**Figure 7B-1. Signs in School Areas and at School Crossings** (Sheet 1 of 2)

# Summary of Comments on CAMUTCD 2026 7B Fig.pdf

# Summary of Comments on Part 7B Figure CA MUTCD 2026

### Figure 7B-5. Example of Signing for a School Zone with Higher Fines for All Traffic Violations (Sheet 1 of 2)

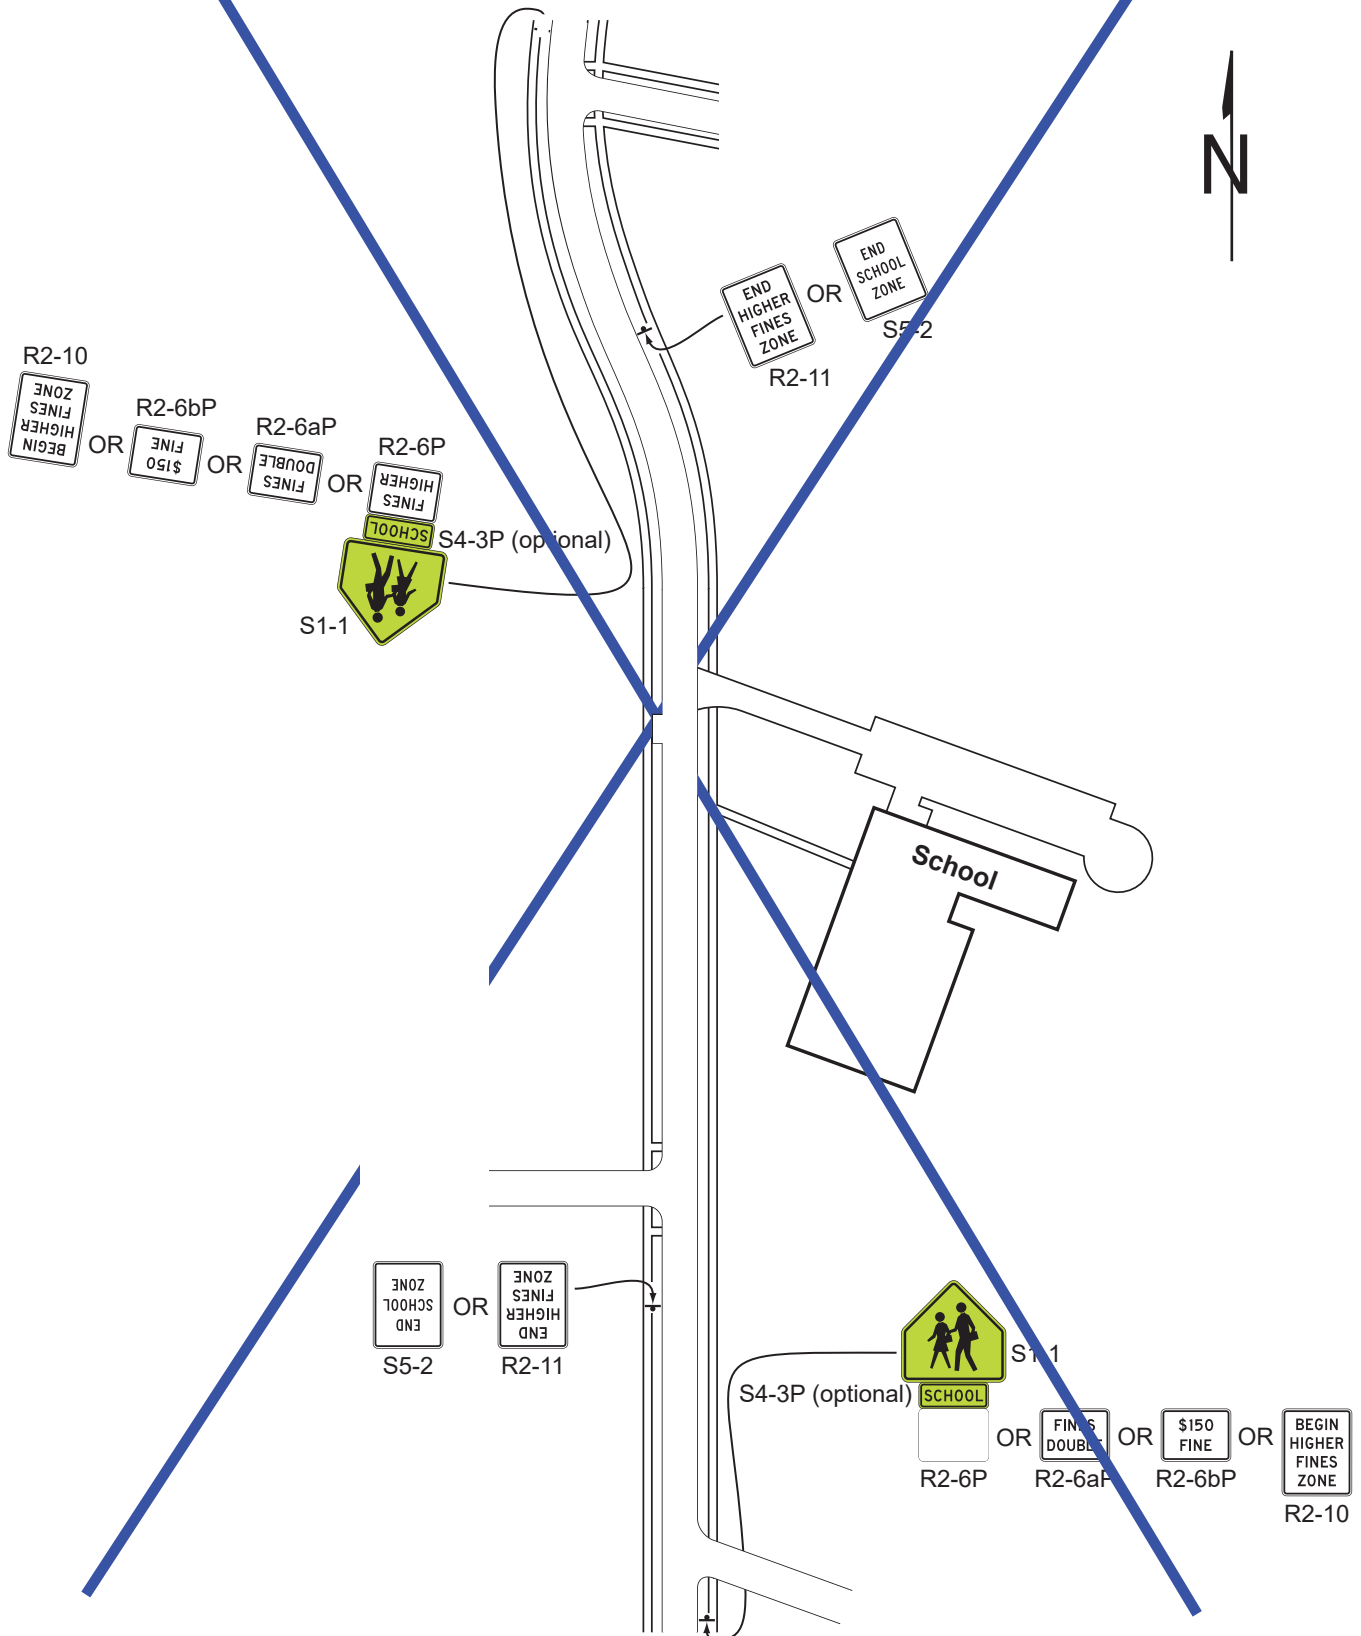
NMUTCD 2023 changed NMUTCD 2009 Figure number 7B-2 to 7B-5 (Sheets 1 and 2 of 2) and made other minor changes in the figure.  
NMUTCD 2023 Figure 7B-5(Sheet 1 of 2) is shown in CA MUTCD 2026 with a blue "X"

**Figure 7B-5. Example of Signing for a School Zone with Higher Fines for All Traffic Violations (Sheet 2 of 2)**

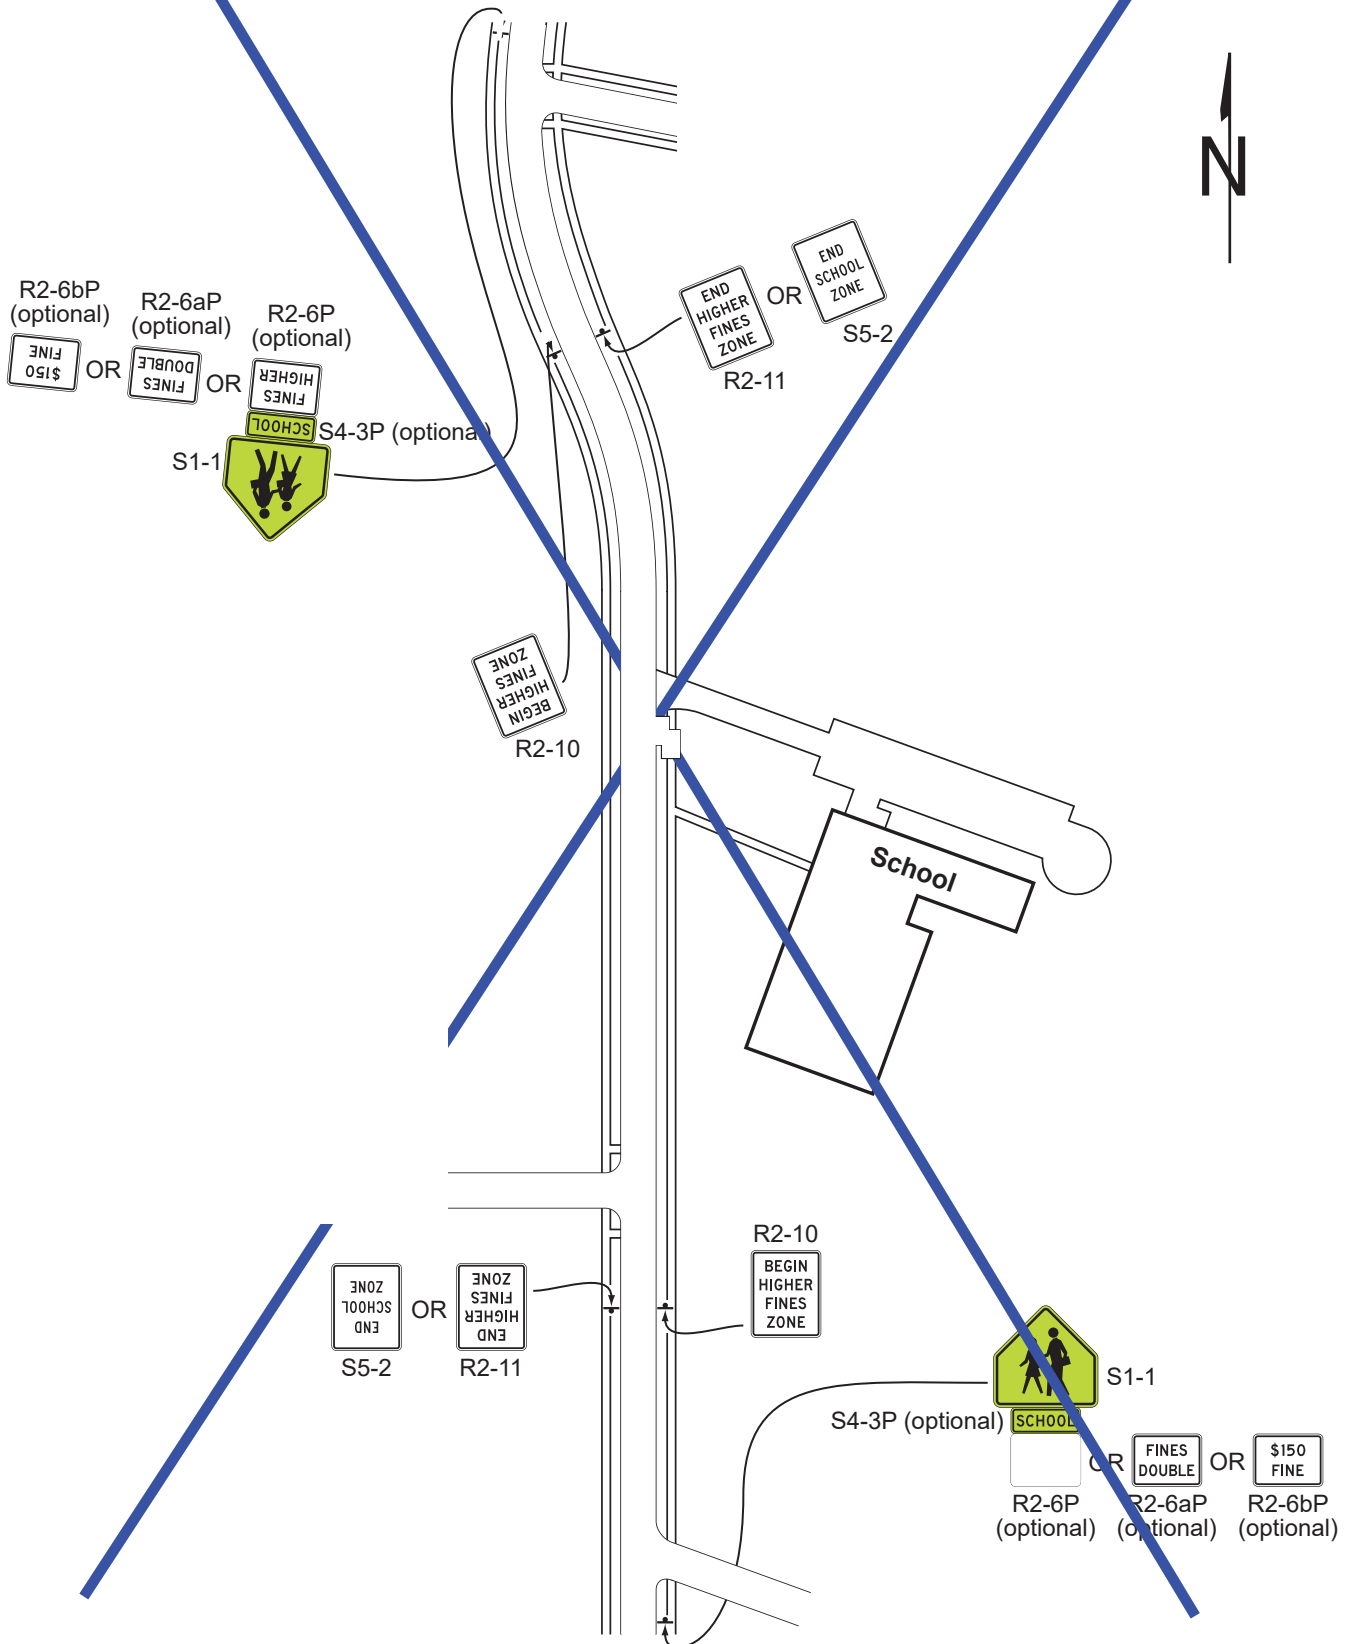
NMUTCD 2023 changed NMUTCD 2009 Figure number 7B-2 to 7B-5 (Sheet 1 and 2 of 2) and made other minor changes in the figure.  
NMUTCD 2023 Figure 7B-5(Sheet 2 of 2) is shown in CA MUTCD 2026 with a blue "X"
